SERVICE BULLETIN

No. SB-AG-73

INSTALLATION OF STALL WARNING FEEDBACK SUPPRESSION RESISTOR

Figure 4

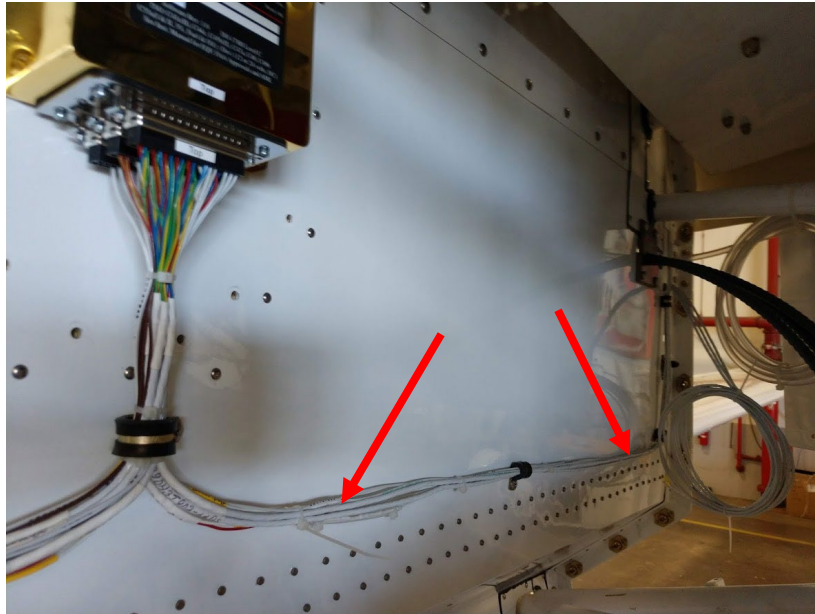
- 4) Locate the best position to install the resistor without bends or crimps in the wire. See Figures 4 and 5 for recommended areas.

(T-34 and T660 Recommended installation in Firewall area shown)

Figure 5

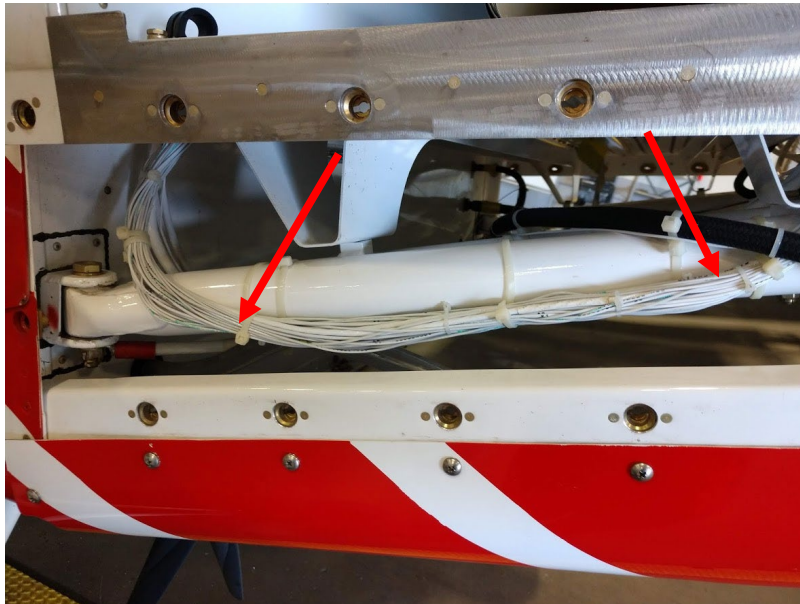
(H-80 Recommended installation RH Engine Mount area shown)

Figure 7

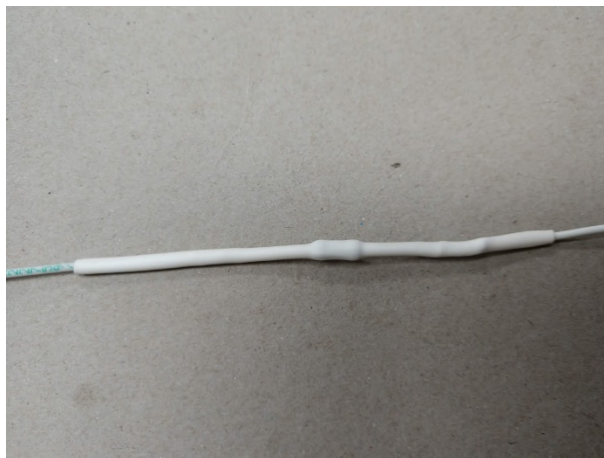
- 7) Apply Heat shrink as in Figure 7.

Wire with Heat Shrink applied
